EPA Response to Comments

**EPA Region 8**  
**Underground Injection Control (UIC) Program**  
**Response to Public Comments**

**Class III Area Permit No. SD31231-00000, Aquifer Exemption Decision**  
**And**  
**Class V Area Permit No. SD52173-00000**

**Powertech (USA) Inc.**  
P.O. Box 448  
Edgemont, South Dakota 57735

Figure U. Pass Creek alluvium cross-section and the Burdock Area Pond locations for the land application disposal option.

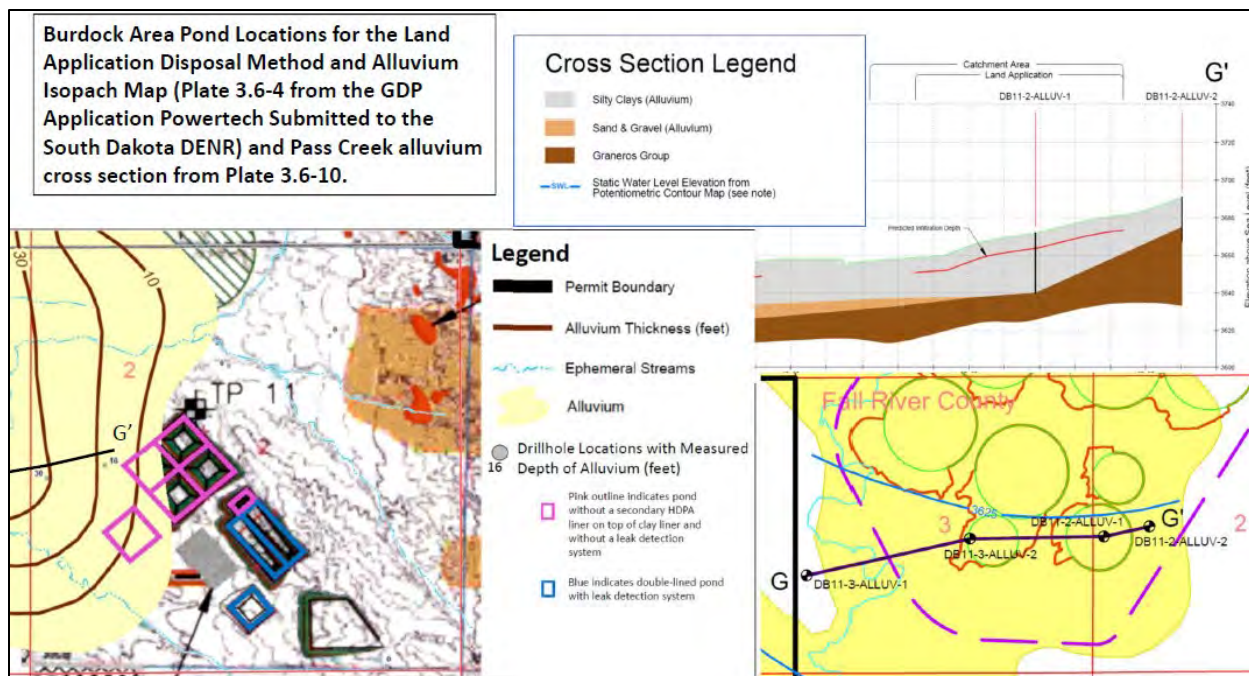
EPA does not agree with Powertech about the potential impacts from a pond leak in this area. EPA performed an analysis of the geological conditions underlying the Burdock Area Ponds to evaluate impacts from the potential leaking of ponds. EPA has concerns that although the ISR waste fluids would have been treated to remove radium, the stored water would still contain byproduct material and high TDS reject water from the reverse osmosis treatment system. Leaking from ponds in this area have the potential to affect alluvial aquifers. Plate 3.6-10 in the Groundwater Discharge Permit Application shows cross-sections of the Pass Creek alluvium and Appendix 3.6-A contains logs from Pass Creek alluvial

Because of EPA’s concern about potential effects to these alluvial aquifers, EPA included a condition in Part II, Section I.4.a of the Class III Area Permit requiring the Permittee to submit information to the EPA Region 8 Air and Radiation Division to determine the applicability of the 40 CFR part 61, subpart W regulations, and if necessary, receive construction approval from EPA. If CAA subpart W applies to these ponds, Powertech will need to meet subpart W requirements. The surface impoundment design, construction, and operating requirements are found under 40 CFR § 264.221(c) which requires two or more liners, installation of a leak detection system, and a leachate collection and removal system between such liners.

**Figure V. Burdock Area Land Application Area and proposed Perimeter of Operational Pollution (Sources: Groundwater Discharge Permit application Figure 6.1-3 and Class III Permit Application Plate 6.12)**

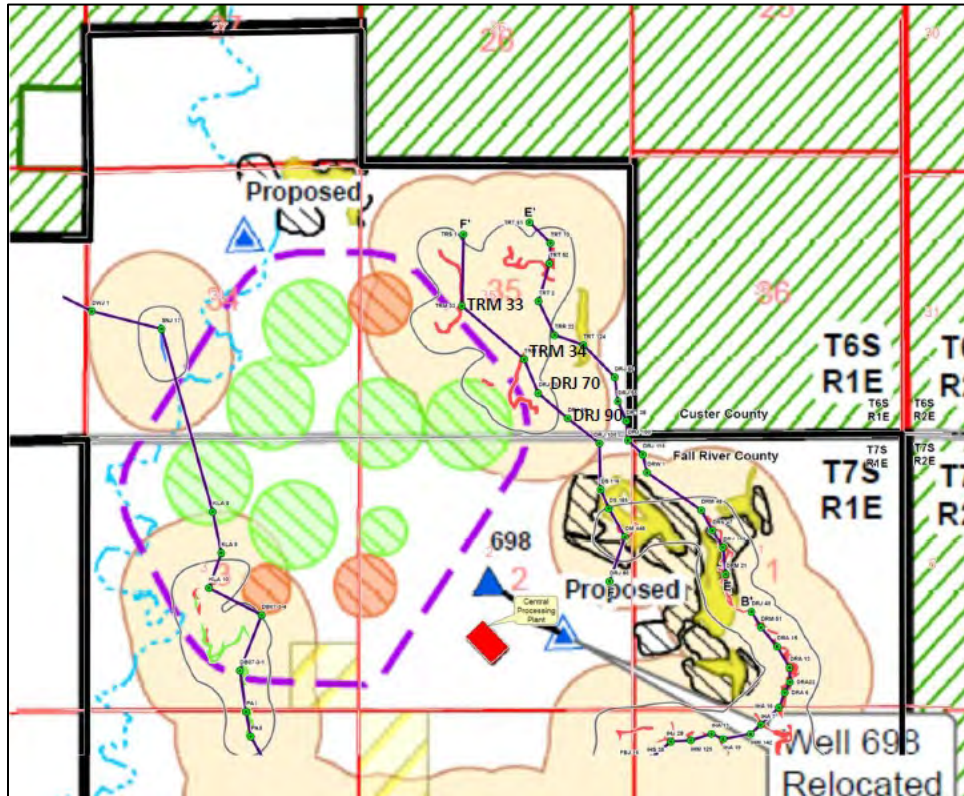
EPA reviewed drillhole data along northeastern POP boundary in the Burdock Area. Figure V shows the Burdock POP boundary from Groundwater Discharge Permit application. Figure 6.1-3 contains an excerpt from Plate 6.12 of the Class III Permit Application showing available cross-sections in the Dewey-Burdock Area. According to Class III Permit Application Plate 6.18 Cross-Section F-F', logs of drillholes TRM 33 and TRM 34 show 10 feet of Graneros Shale. Because the Graneros Shale has been eroded away in this area, logs of drillholes DRJ 70 and DRJ 90 show the Graneros Shale is absent above the Fall River Formation. Because these drillhole locations are located outside the POP boundary, they do not necessarily indicate the Graneros is less than 25 feet thick within the land application areas. Groundwater Discharge Permit application Plates 3.6-9 Cross-Section E-E' and Plate 3.6-8 Section D-D' show that the Graneros shale is 25 feet or more within the land application areas. Cross-Section F-F' in Plate 6.12 of the Class III Permit Application also shows that the Upper Fall River is not saturated at the locations of drillholes TRM 34, DRJ 70 and DRJ 90. Powertech proposes vadose zone monitoring at catchment areas (which are shown in Figures 6.1-2). EPA considered whether monitoring wells should

be completed in the Fall River aquifer at the northeastern POP boundary and determined that the catchment area vadose zone monitoring at the northeastern edges of the Burdock land application area will also serve as monitoring for the Fall River aquifer in this area. In addition, the Upper Fall River aquifer monitoring wells associated with Burdock Wellfield 8 will also provide monitoring for TDS, specific conductance, and alkalinity at the northeastern POP boundary.

**Figure W Projected Construction, Operation and Decommissioning Schedule (Source: Figure 10.2 in the Class III Permit Application.**

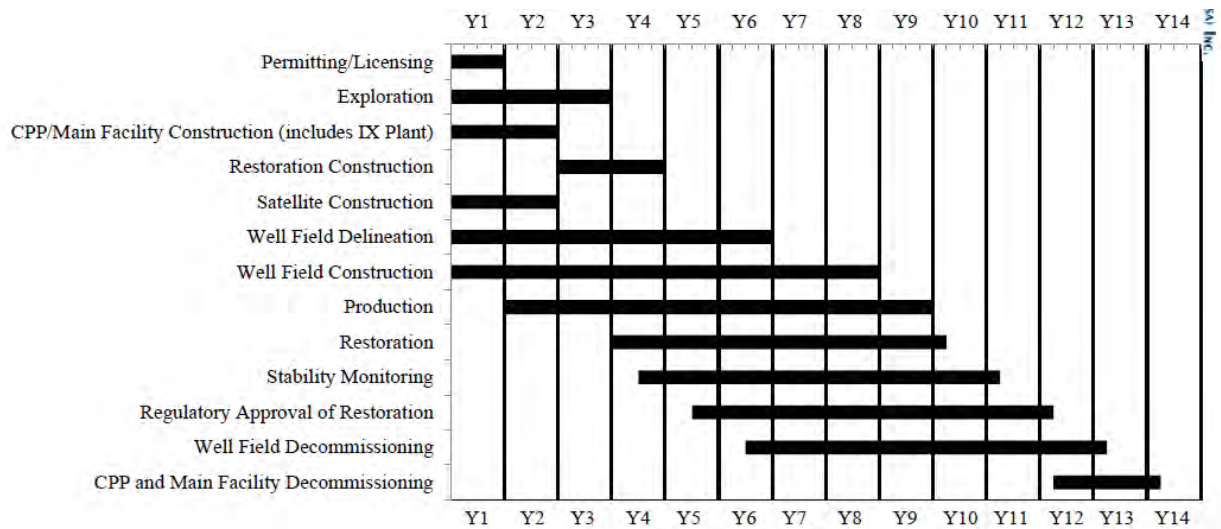
The Class III Permit Application includes the project timeline in Figure W showing an estimated life of the project to be 14 years. Not all 14 wellfields will be in operation at the same time, because Powertech plans to initiate wellfield phases (construction, operation, restoration, closure and decommissioning) sequentially for each wellfield. Figure X shows an example of this sequential approach for Burdock Wellfields 1 through 10.

Although the Class III Area Permit has been issued for the life of the project, if Powertech proposes additional wellfields, the company must apply for a major permit modification, which will trigger an updated CEA that will address additional wellfields and the extended project life. A major permit modification will also require another public comment period. Conducting an analysis before that time would be based on speculation instead of actual data. The Class V Area Permit expires after 10 years. Renewal of the Class V Area Permit will provide another opportunity for public comment and an updated CEA. By the time a Class V permit renewal or Class III permit modification occurs, operational information should be available on the amount of time actually needed for each wellfield phases to better inform the life of the project.

Figure 3.2-6: Overall Process Flow Diagram

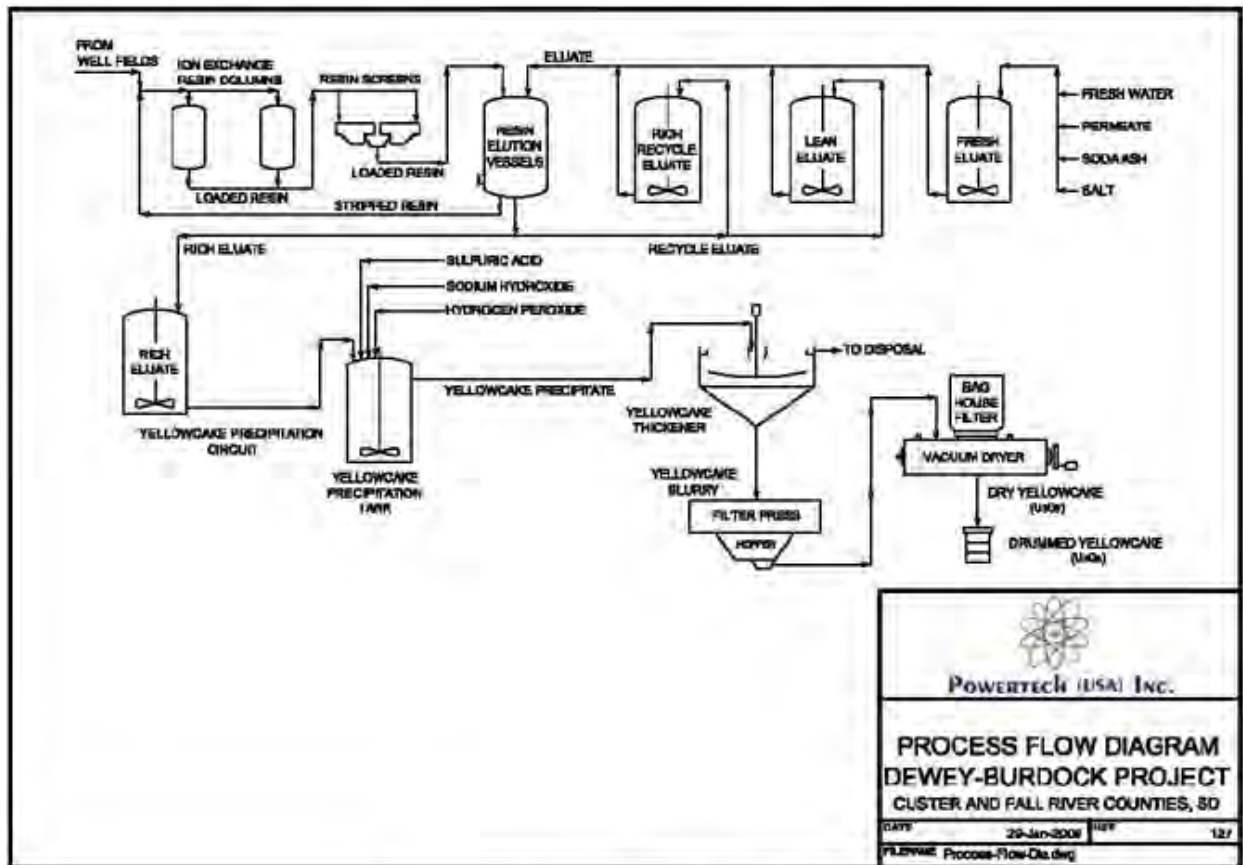
361. Powertech raises a comment regarding the statement in the CEA that Powertech proposes to store, use, and receive shipments of anhydrous ammonia (NH<sub>3</sub>). According to Powertech, it does not propose to use ammonia at the Dewey-Burdock Project. Powertech refers to Figure 3.2-6 in the approved NRC license application and explains that it shows that sodium hydroxide will be used in the precipitation circuit instead. Powertech also refers to Table 3.2-1 in the approved NRC license application, which lists the process-related chemicals and quantities planned for the project, likewise does not include ammonia. Powertech requests removing mention of anhydrous ammonia from this paragraph.

EPA agrees with Powertech’s comment and has updated the two references to “anhydrous ammonia” (NH<sub>3</sub>) in the CEA Section 12.2, and instead replaced them with sodium hydroxide. We have included Figure 3.2-6 in the approved license application here.
